## Written Notes from The Cambrian Mountains Society for deadline VI - 26th March 2015

### The worst case

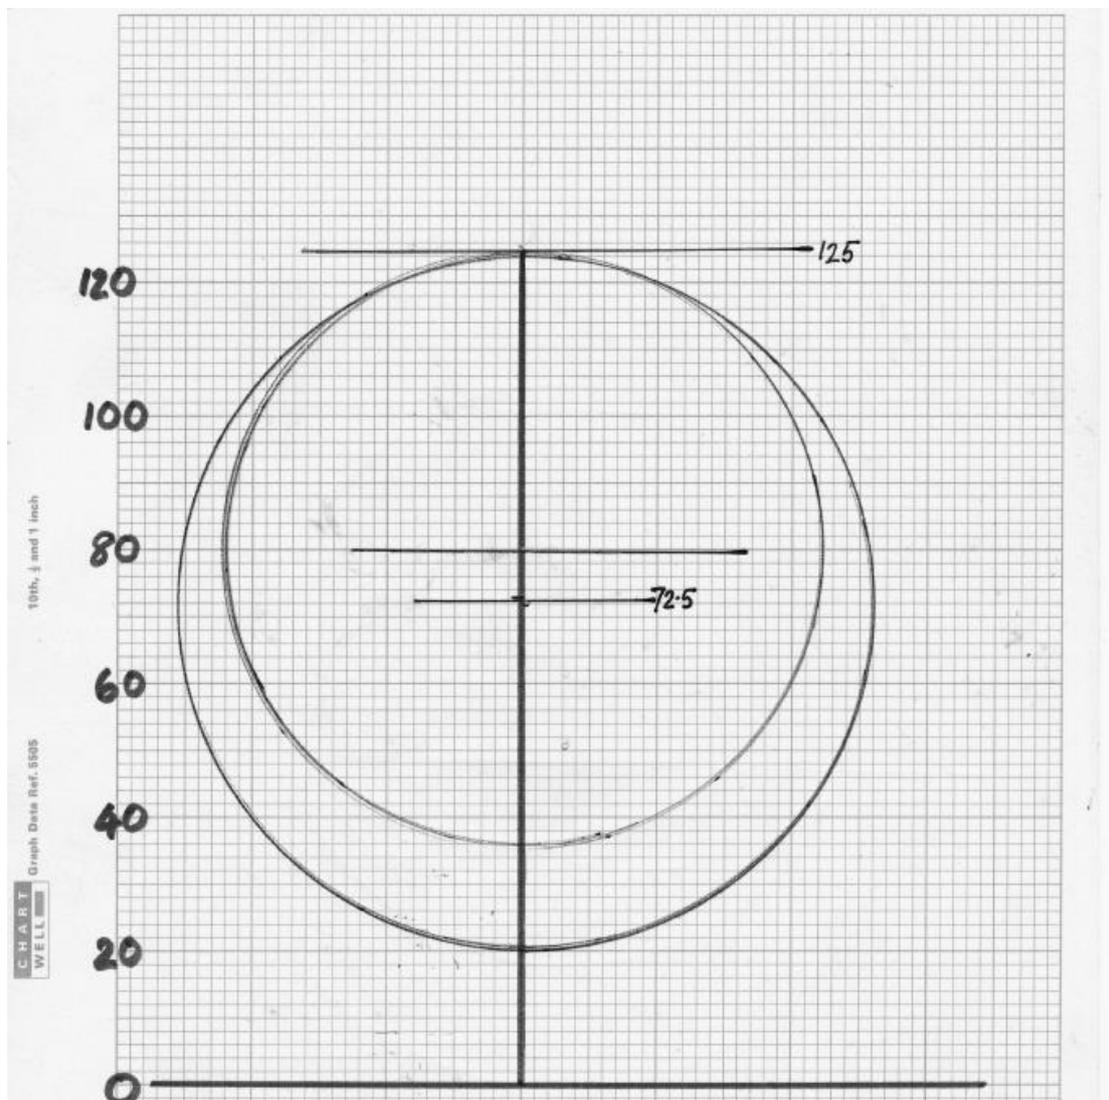
At section 2.7 the ES provided a schematic drawing, but this is imprecise and misleading. The rough sketch below is sufficiently accurate to demonstrate the differences.

The CMS would particularly draw the ExA's attention to the increased swept area of the 52.5m radius blades, which is 36% greater than that for the standard 45m blades. The recently produced revised visualisations are configured in such a way that even where the additional blade length is discernible and correctly shown, this massive increase is not fully apparent. Moreover, the blade-sweep, while reaching to the same tip height, is only 20m from the ground at its base, thus creating a more complex and visually intrusive visual network of movement, with greater potential for overlap and interplay between the turbines when seen as a moving mass.

The larger-bladed turbines do not just represent a different case, but the worst case **and a far worse case**, considering the changed visual characteristics of the 52.5m radius, key distances and dimensions, and shown in the drawing above.

Given that none of this has been discussed, illustrated or assessed, they cannot be considered as an alternative, and accordingly that option (or any including these significantly larger blades) cannot be included within the terms of the DCO. The CMS submits that the applicants should therefore withdraw such an option in order to proceed, or that the ExA should require that the Order only applies to the  $80 + 45 = 125\text{m}$  turbines as assessed in the ES and considered by the public, consultees and relevant planning authorities.
